Drawing Title
COVER SHEET

PROPOSED MIXED USE DEVELOPMENT

47-50 THE ESPLANADE ETTALONG BEACH

S75W SUBMISSION

Drawing Title
**LEVEL 05
FLOOR PLAN**

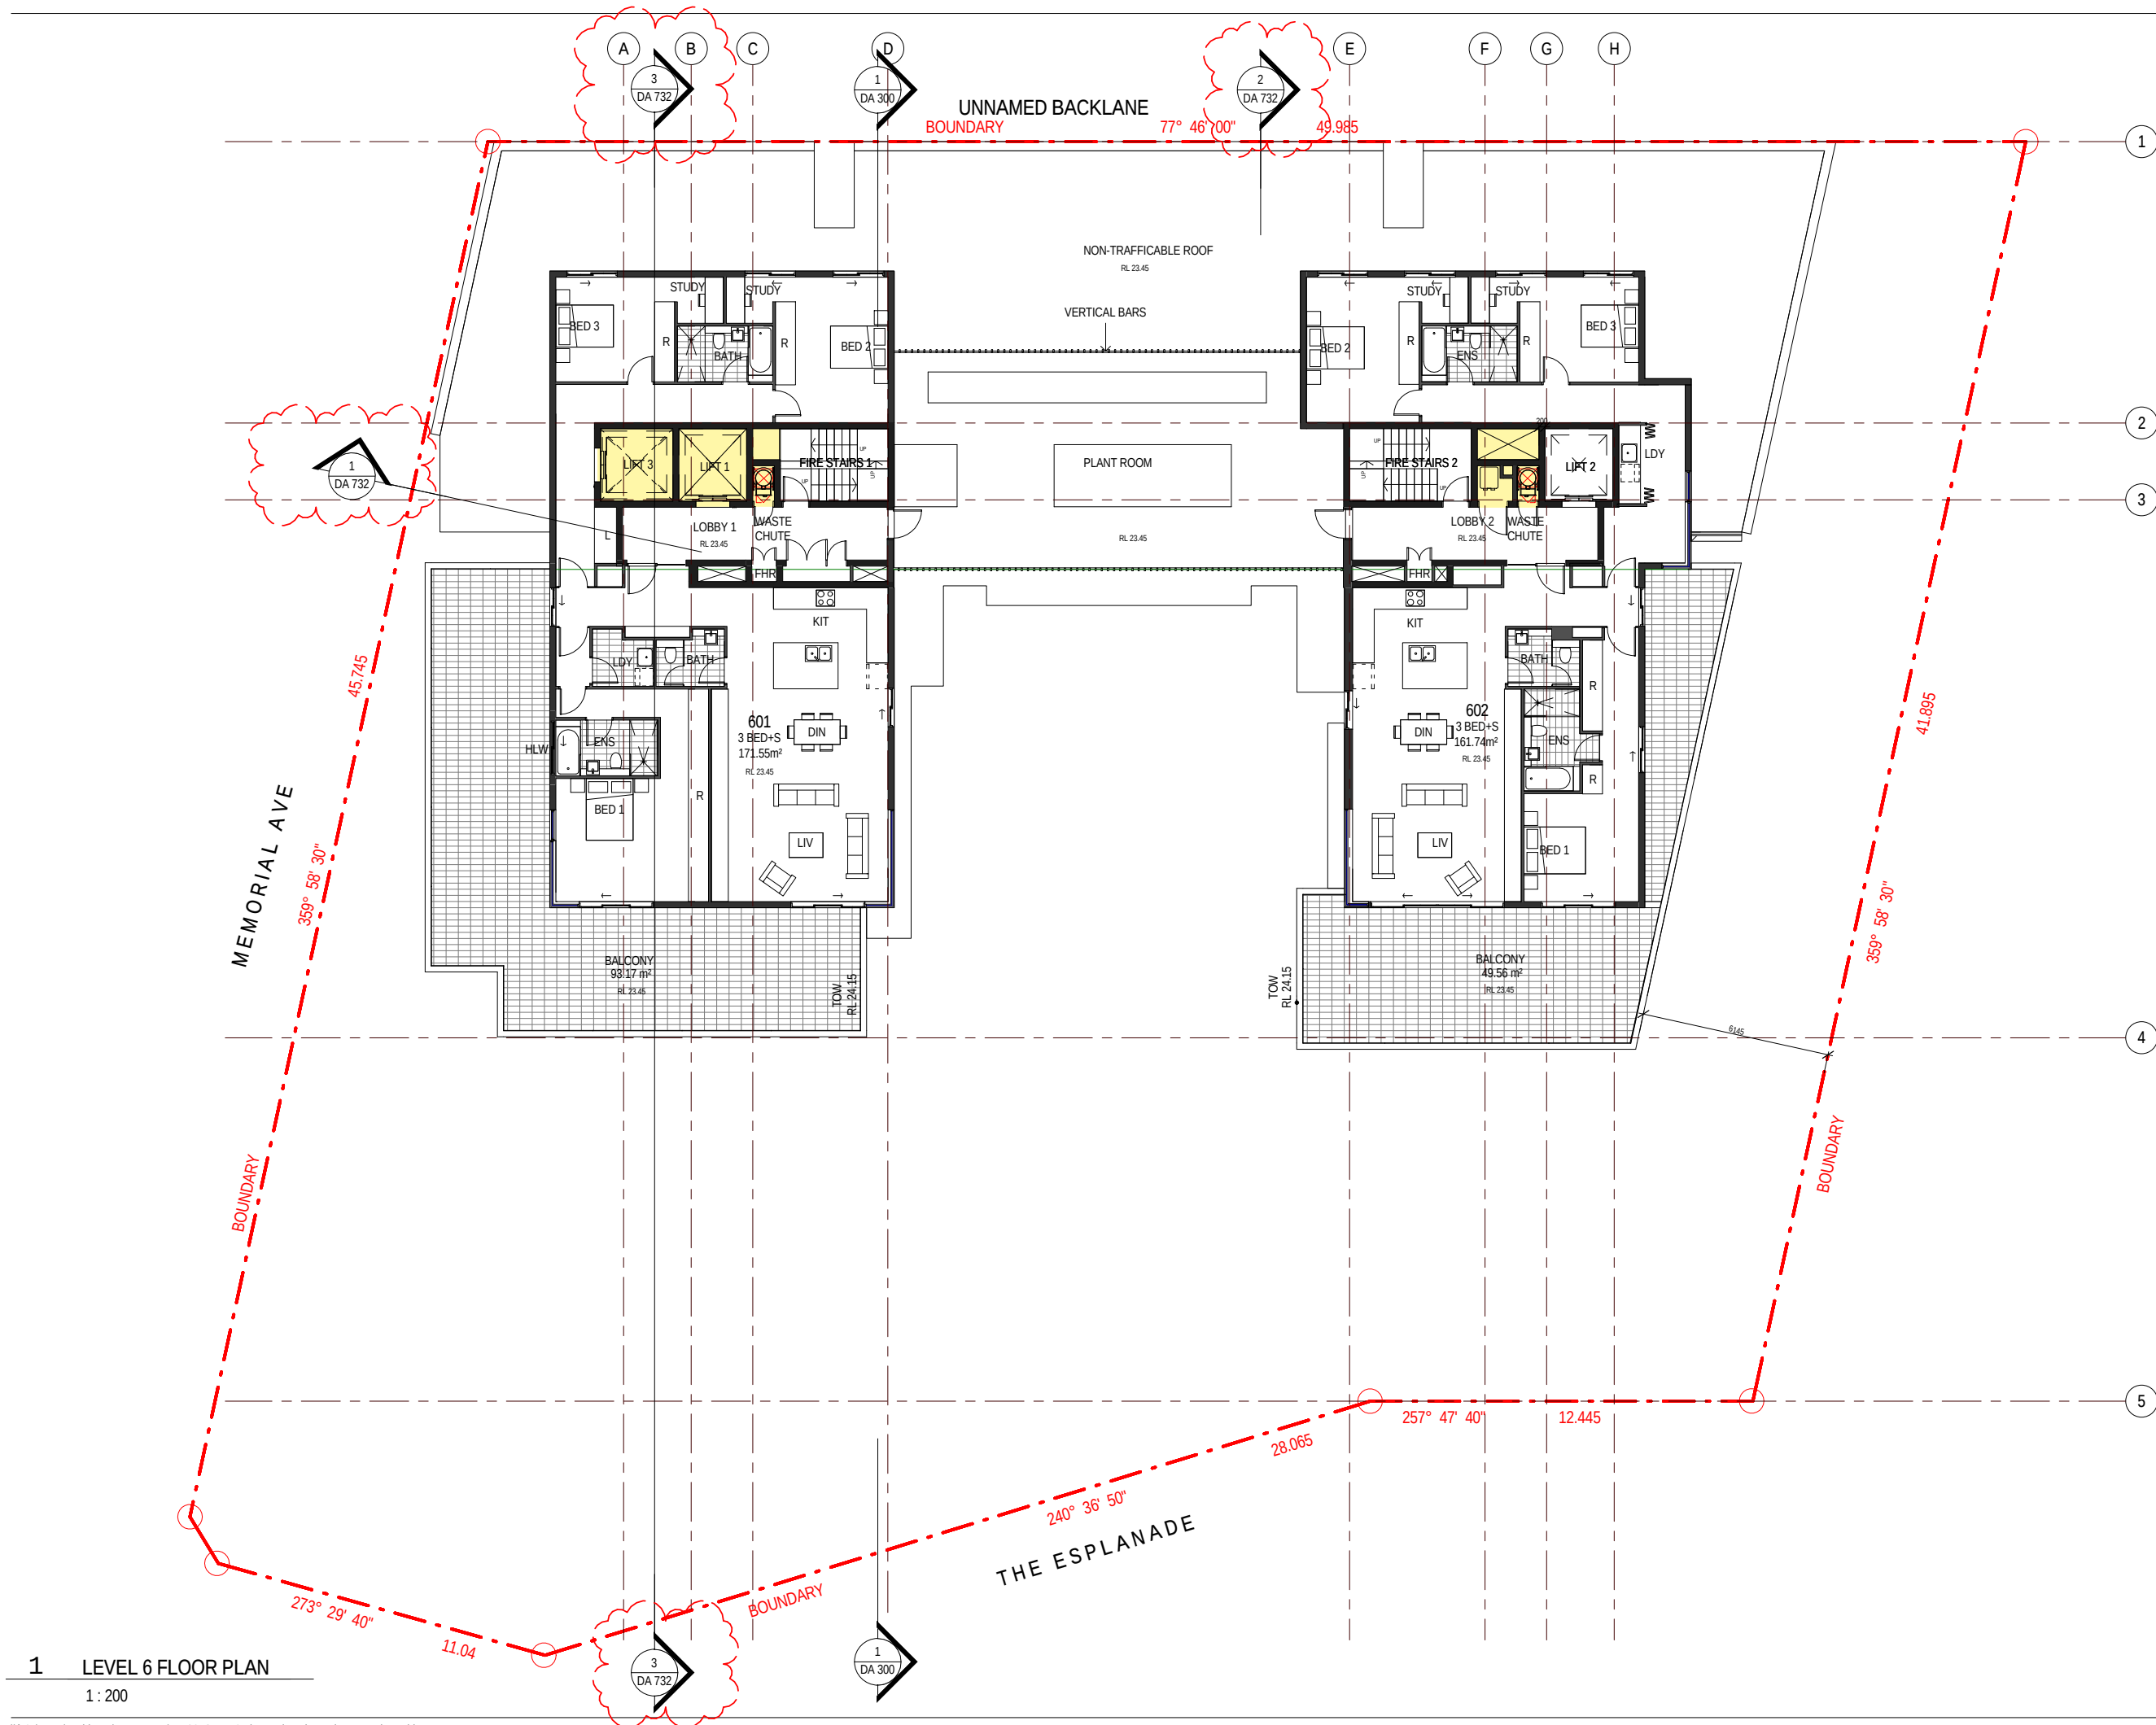
- LIFT03 ADDED / LIFT01 RELOCATED
- LIFT CORE / WASTE SHAFT & RECYCLE BIN ROOM REVISED
- SIGHTLINE DIAGRAM MARKERS ADDED

1 ROOF LEVEL PLAN
1 : 200

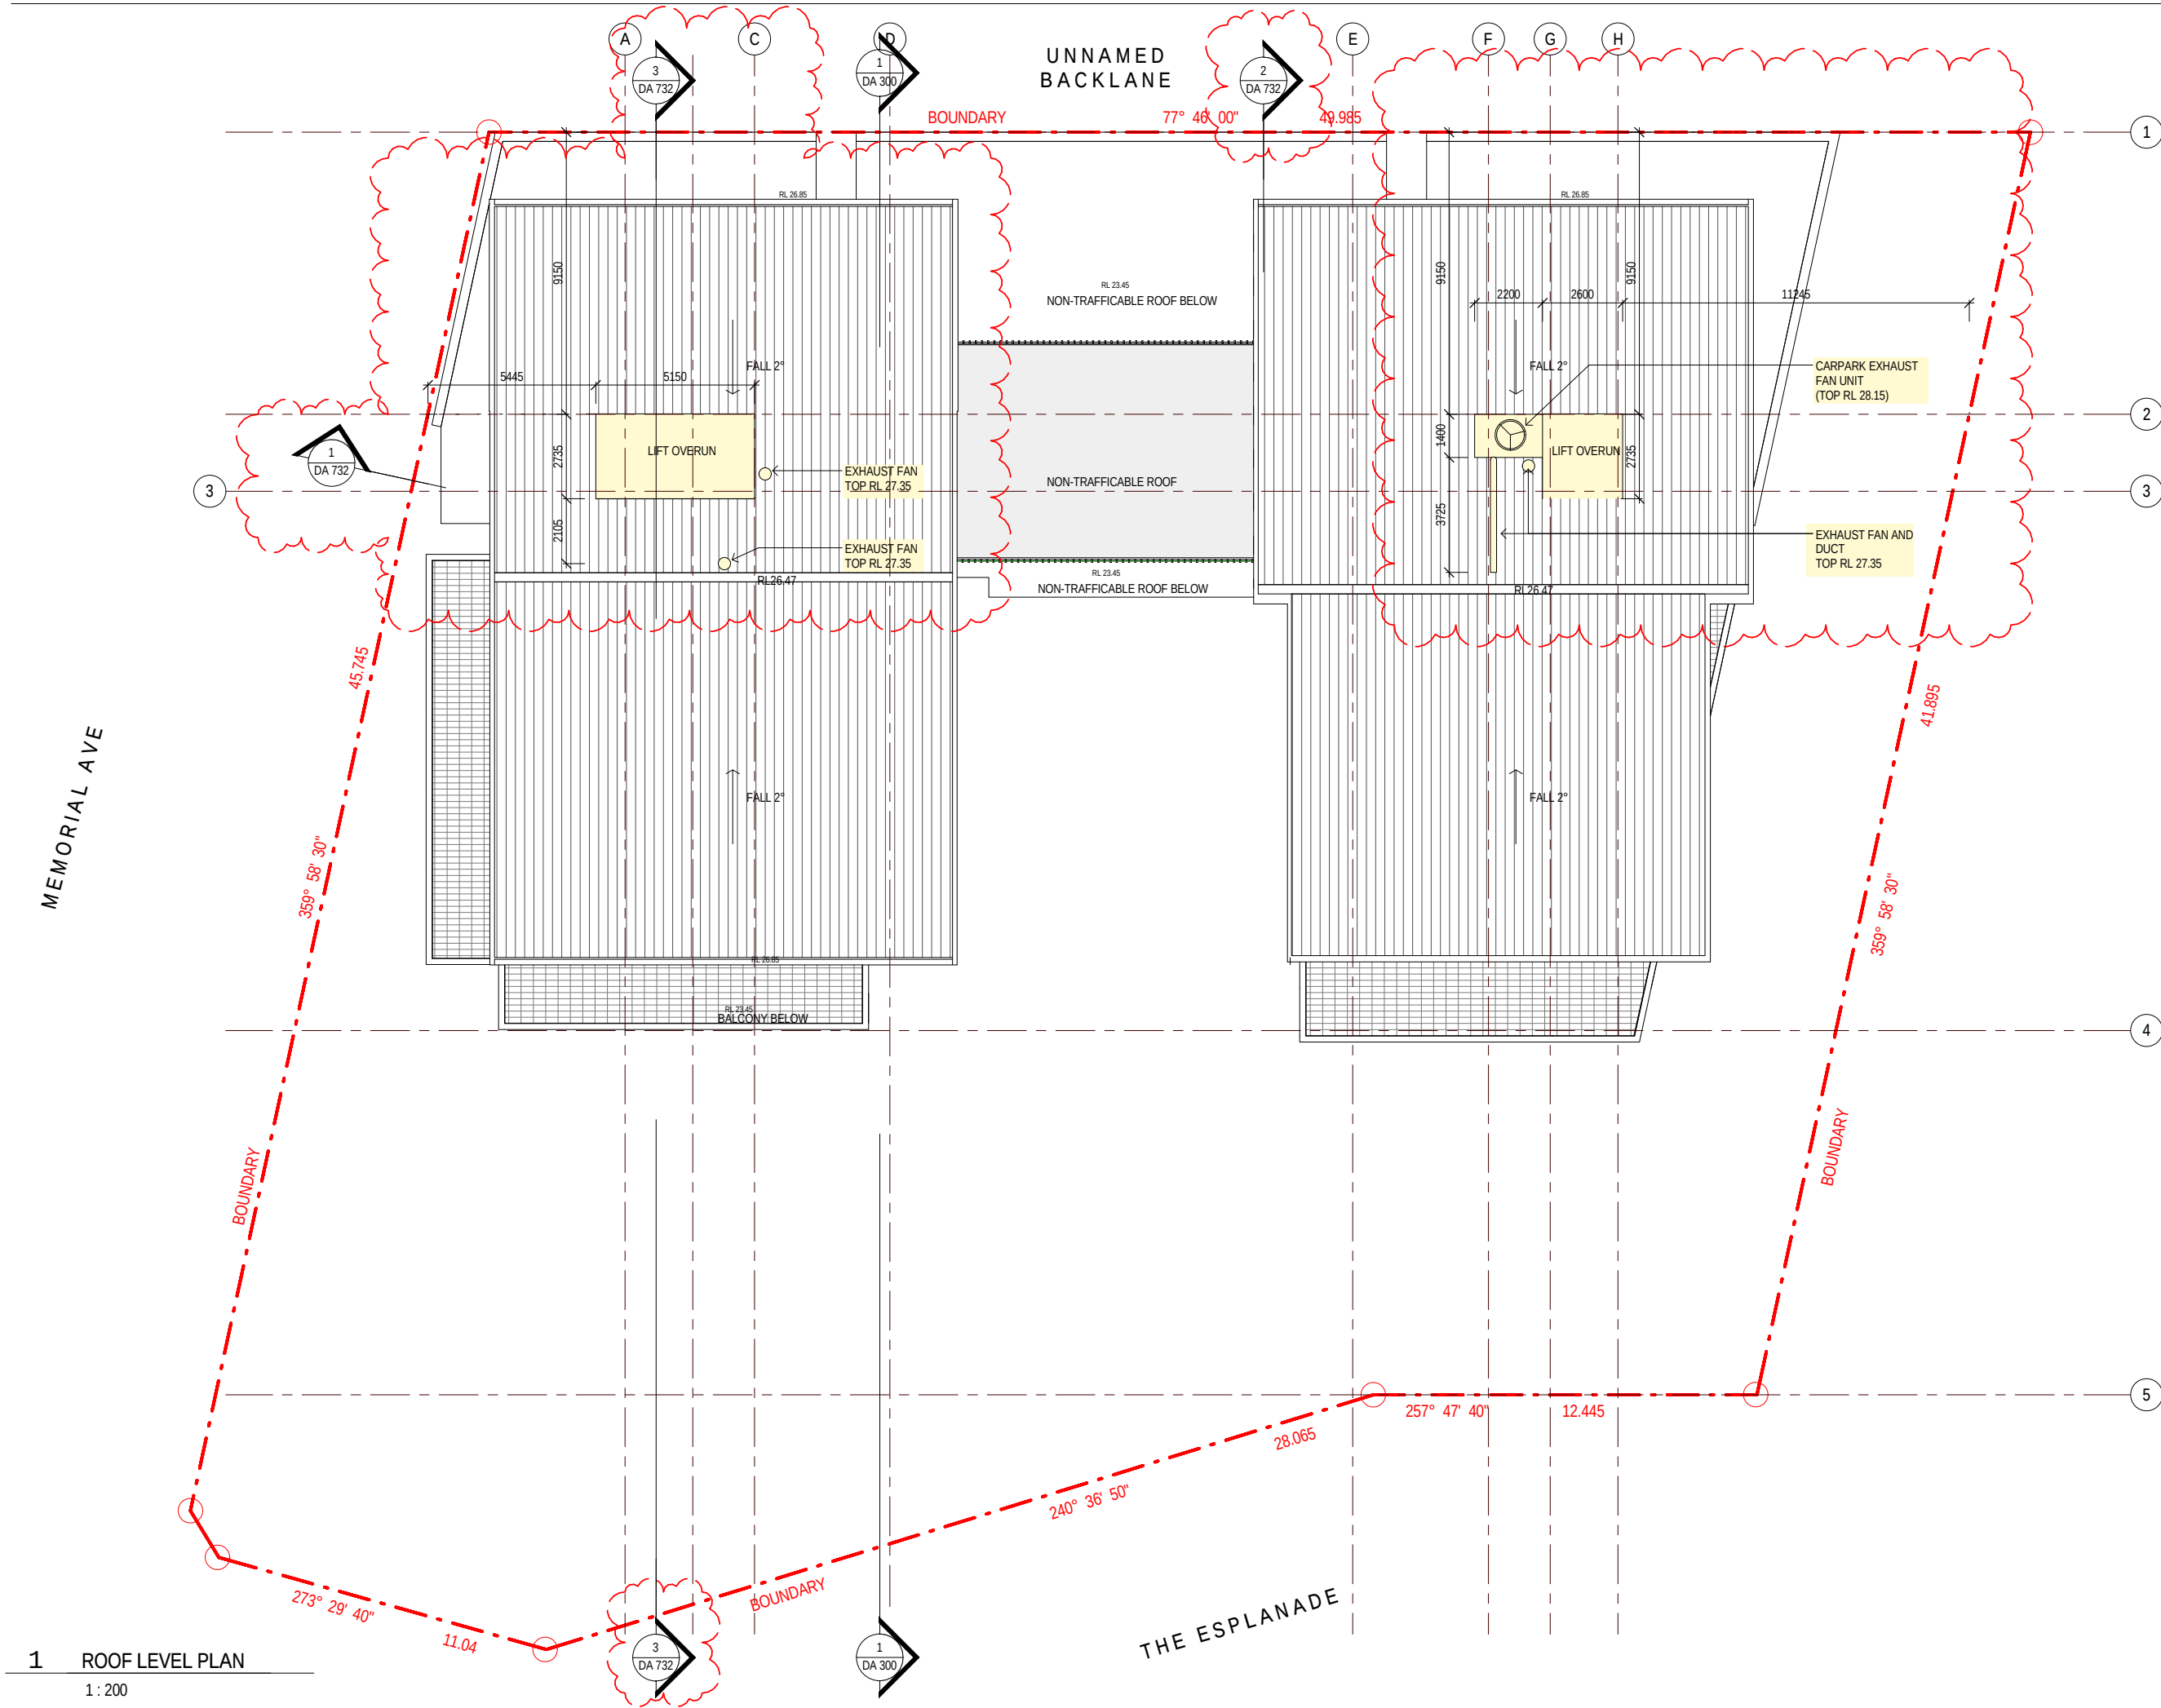
- LIFT OVERRUNS ADDED
- EXHAUST FANS ADDED ON ROOF
- SIGHTLINE DIAGRAM MARKERS ADDED

Drawing Title
NORTH & SOUTH
ELEVATIONS

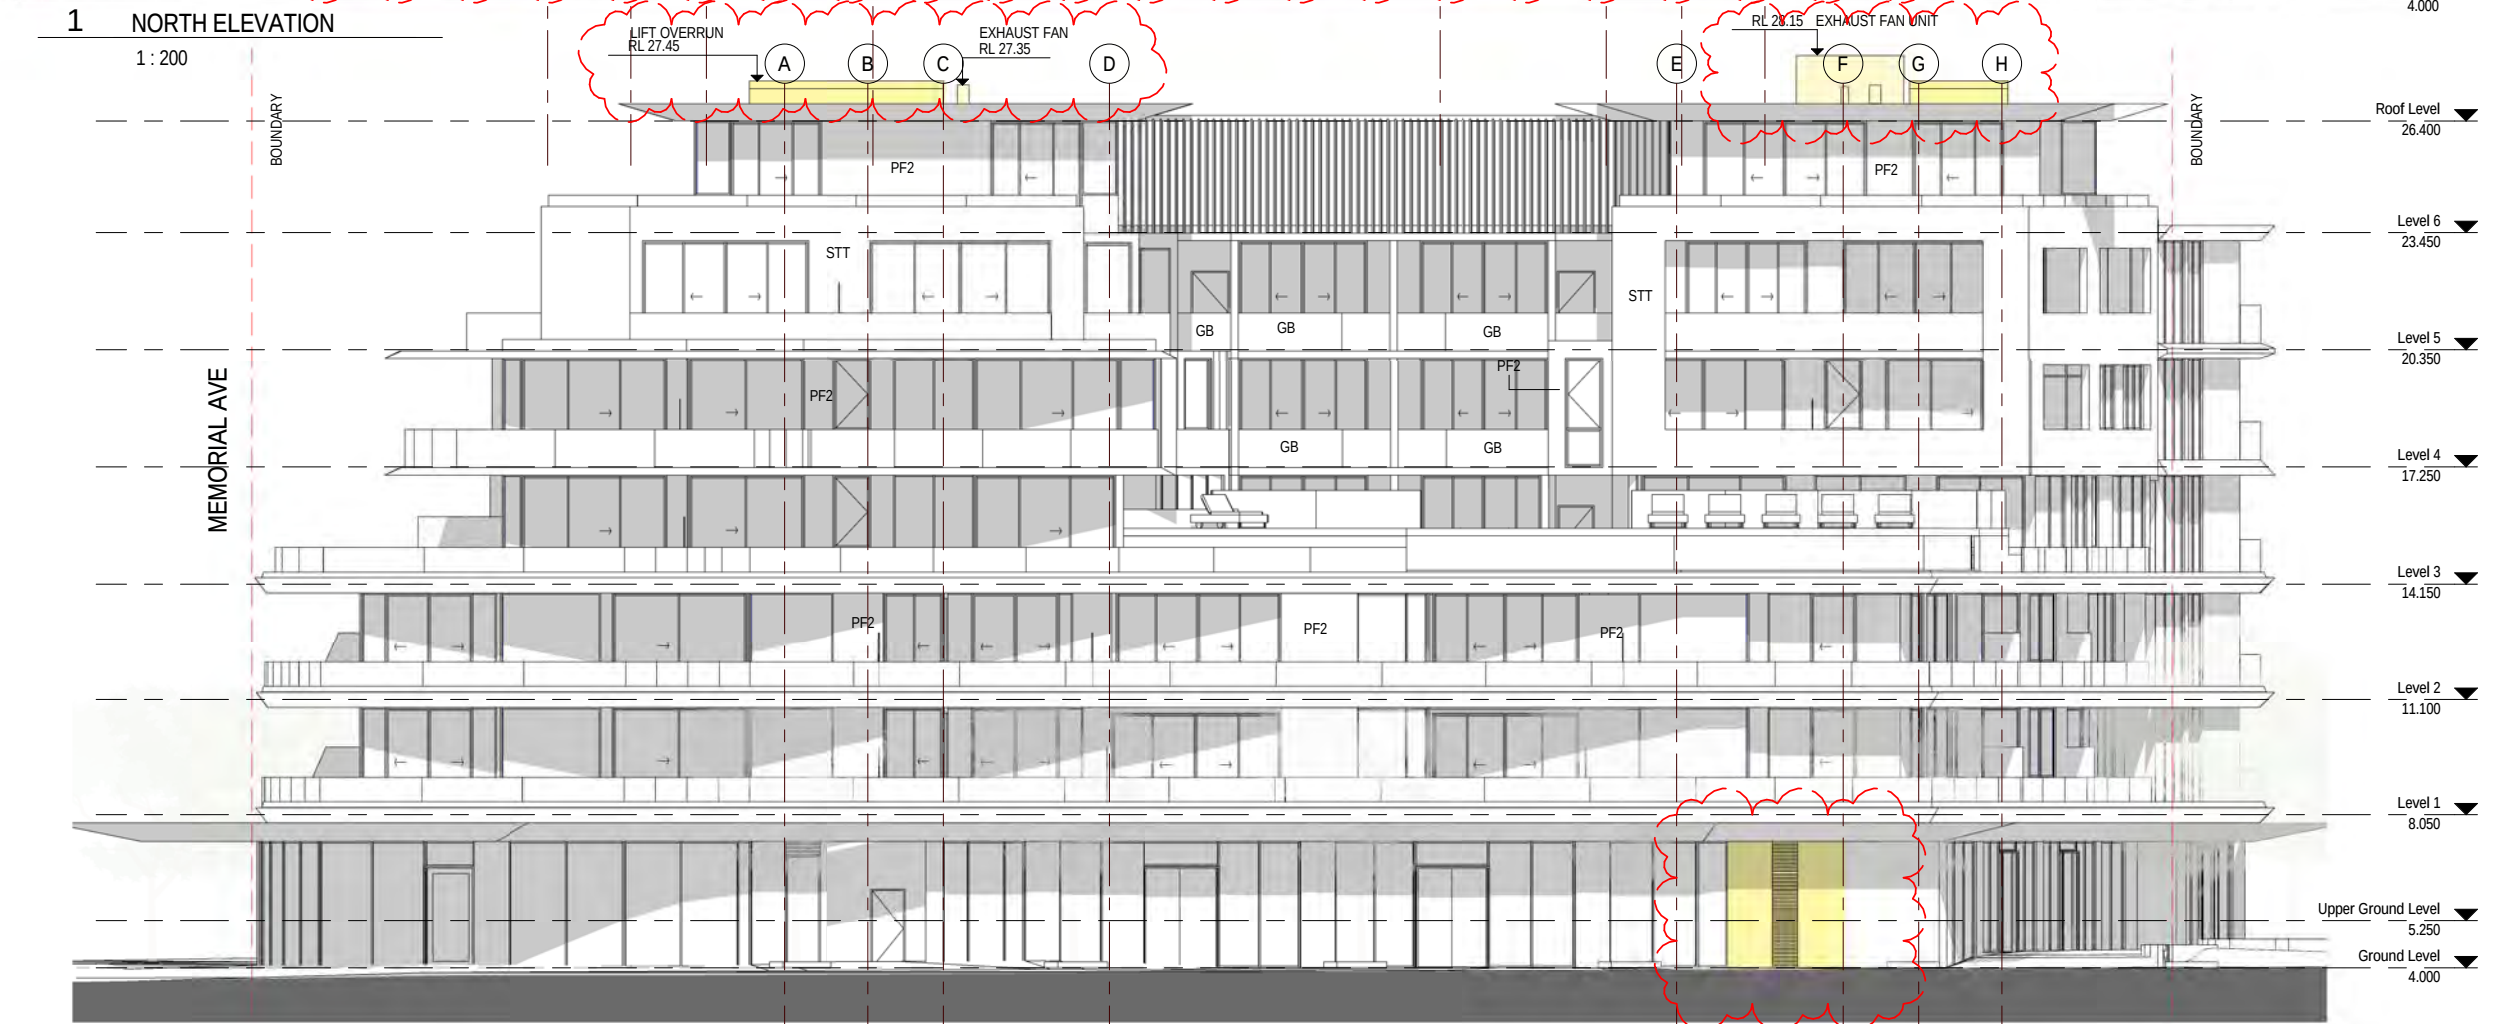
- FRESH AIR INTAKE LOUVRE ADDED TO SOUTH ELEVATION
- GARBAGE / CARPARK DOORS REVISED & FIXED
- GLAZING ADDED ON NORTH ELEVATION
- LIFT OVERRUN AT ROOF LEVEL
- EXHAUST FANS ADDED ON ROOF
